PC3XS TO PDM70

TECHNICAL INFORMATION

EP-PC3XS-TI-L

Tech Tip Index

PC3XS Controller Module

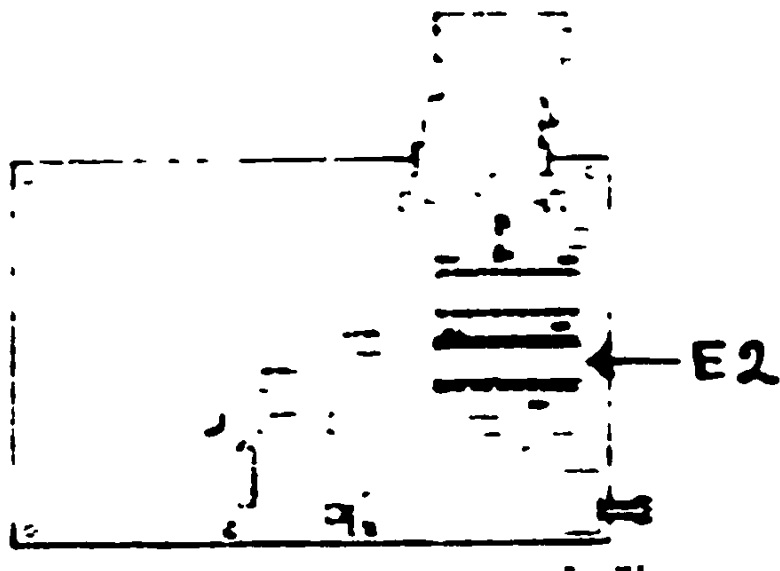
With the release of P/OS V1.7 and an upgrade to the RX50 controller, CP/M will now support 96TPI diskettes (48 TPI). The hardware upgrade consists of an EPROM which is installed on the RX50 controller in location E2 (See diagram).

Field Service should be aware of this when servicing a customer who has the CP/M option installed. If the RX50 controller has to be replaced for any reason, be sure to remove the EPROM, if present, from the defective RX50 controller and install it on the replacement module.

E2
Old part number - 23-0100-01
New part number - 23-0190-01

FIGURE 1

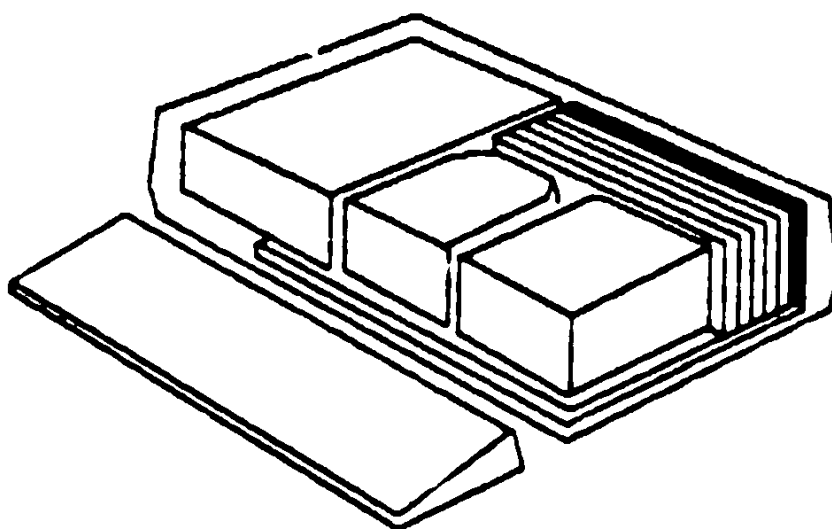
Problem/Symptom: When Revision "A1" or "B1" 54-15539-01 is used on the PRO380, the power-up diagnostics will fail with the error "060001/000046" (See Figure 1).

Remove the out of revision PC3XX-AA (54-15539-01). Replace with the 54-15539-01 Revision "B2" or greater. Run power-up and Maintenance Service Diagnostics. See page 4 of 4 or PC350/380 Pocket Service Guide for detailed procedure.

FIGURE 2

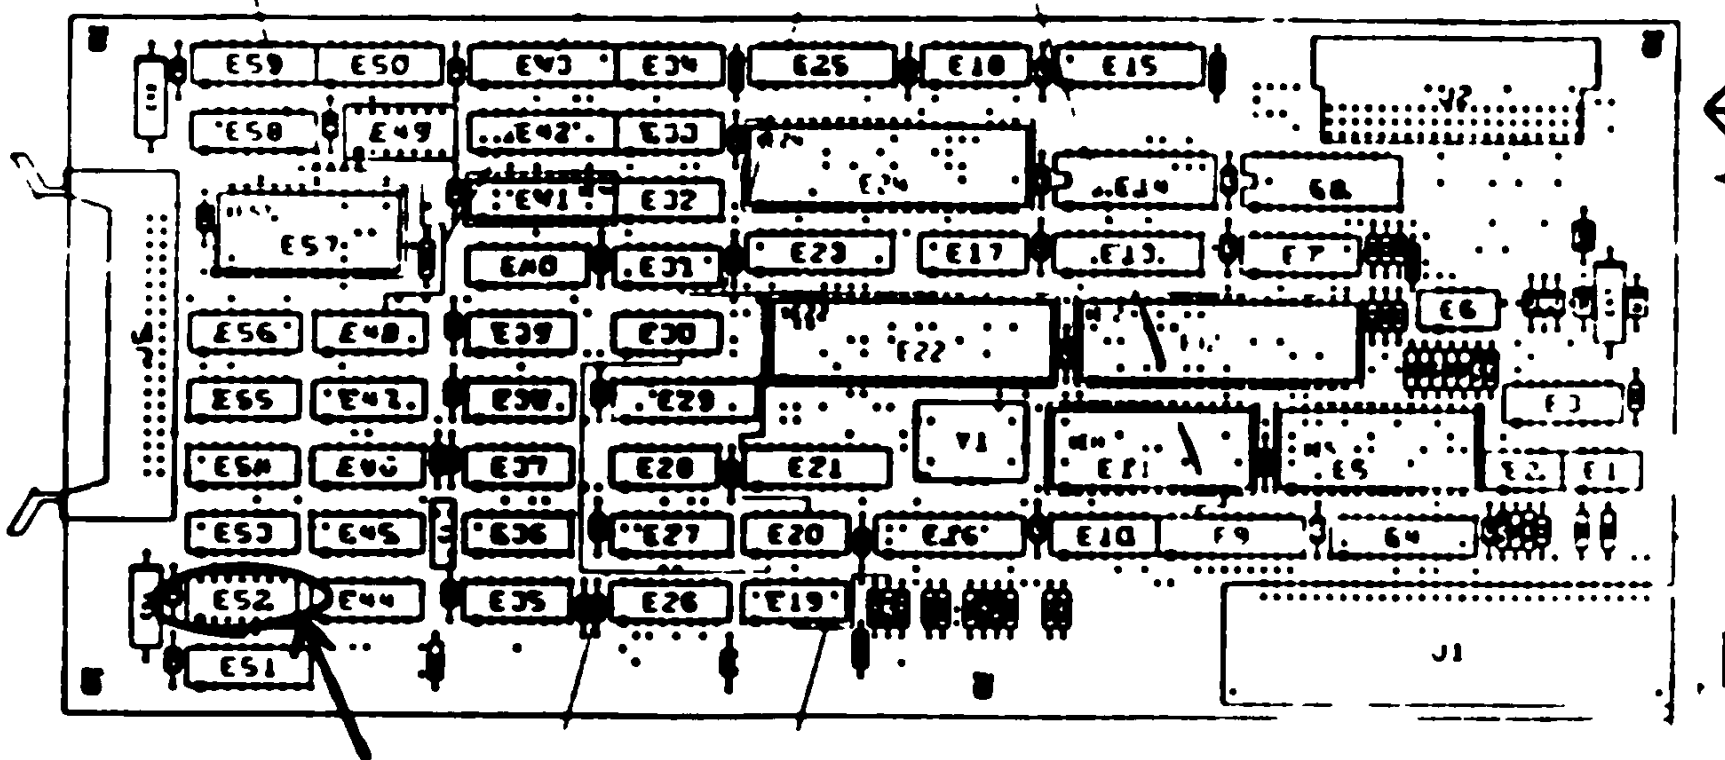
Revision "B2" has a chip in location E52.
(See Figure 2).

QUICK CHECK: Presence of Chip in Location E52. (74374).

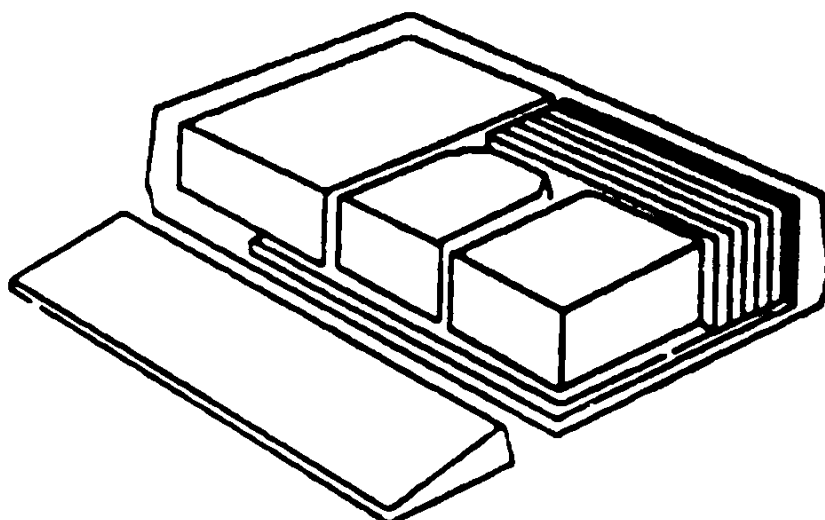
When a revision A1 or B1 PC3XX-AA (54-15539-01) is used on a PC380 the power-up diagnostics will fail with the following error, "060001/000046". (See figure 1, page 2.)

Remove out of rev 54-15539-01 and replace with a revision B2 or greater. Refer to the PC350 or PC380 Pocket Service Guide or page 4 of this Tech Tip of detailed removal and replacement procedure.

QUICK CHECK: Presence of Chip in Location E52. (74S74).

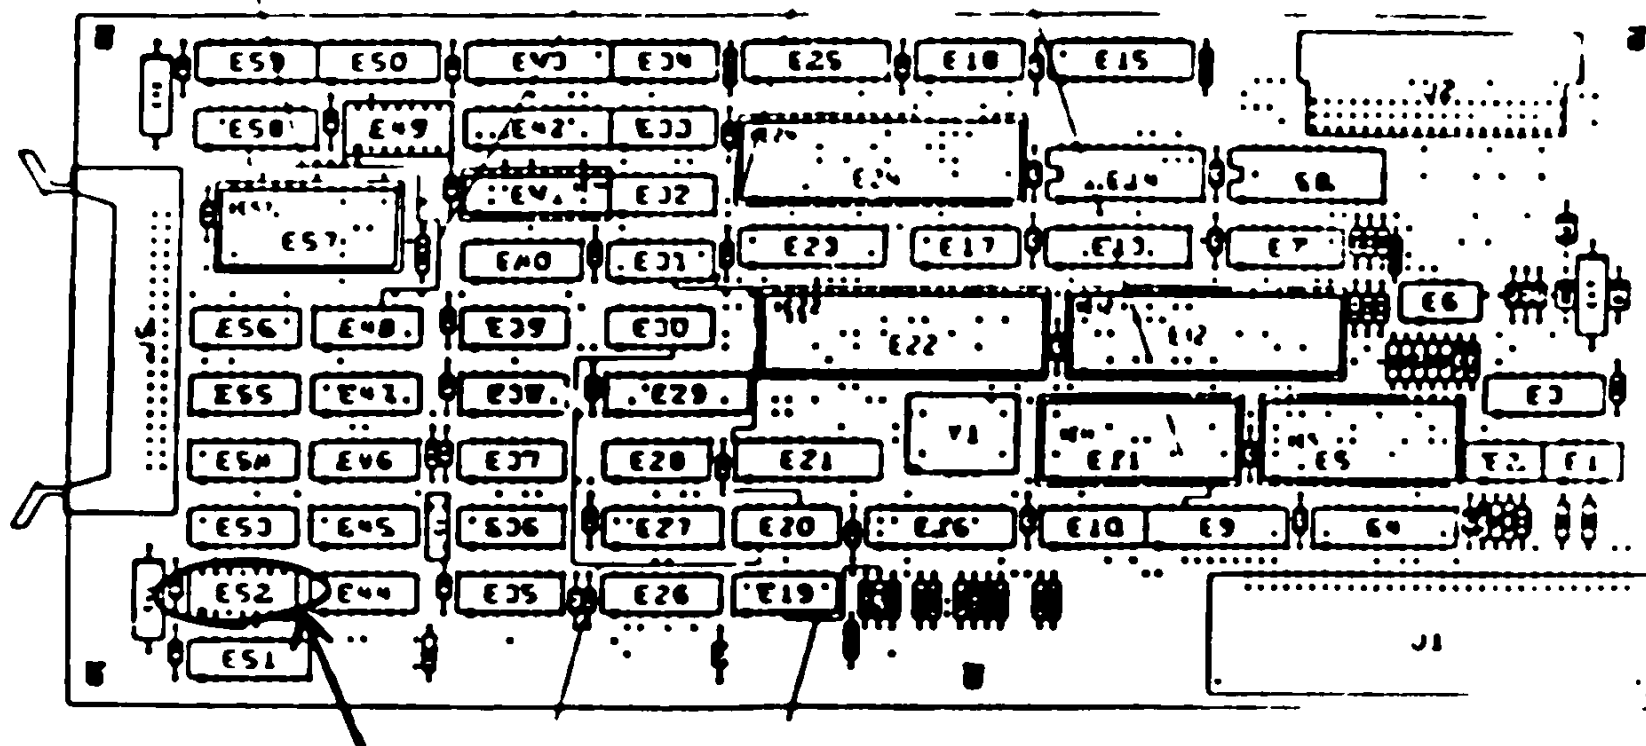
A quick check for the proper revision level is a chip in location C2. (See figure 2, page 3.) Presence of chip indicates proper revision level for PC380.
